Docket Item # 4
BAR CASE # 2009-0292

ISSUE: Alterations
APPLICANT: Sheri Bango Caveney
LOCATION: 1250 S. Washington Street (Unit 420)
ZONE: RC/Residential

The applicant is requesting a Certificate of Appropriateness to enclose a balcony at unit 420 of the Porto Vecchio high rise residential condominium building at 1250 South Washington Street. The proposed construction comprises the installation of new solid glass kneewall and new solid glass and screen rolling panels into the existing structural components. The existing floor, wall framing, and ceiling are to remain as-is without alteration. The proposed framing material is extruded aluminum in an anodized Quaker bronze finish. The proposed glass will be tempered and laminated with a SB70VT Low-E coating.

Figure 1: Diagram of proposed alterations.

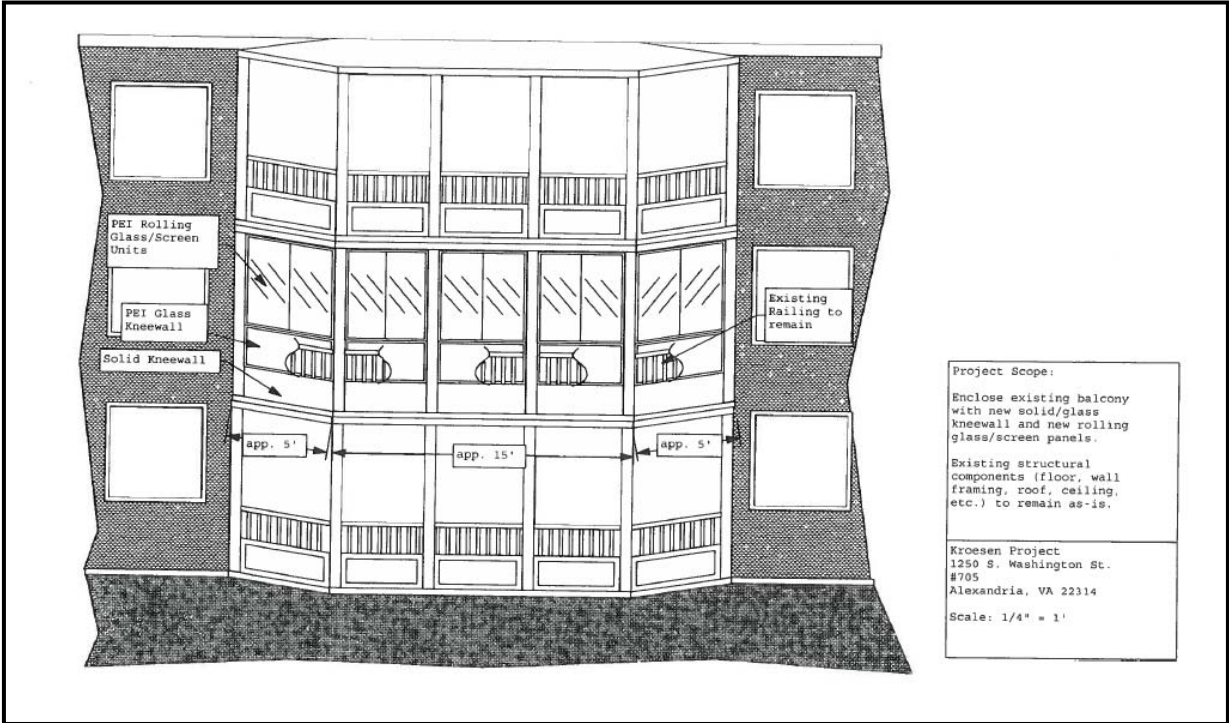
Staff recommends approval of the application as submitted, due to the fact that the proposed balcony enclosure does not affect the structural integrity of the building and the alterations are in keeping with prior approvals of the Board at the same location.
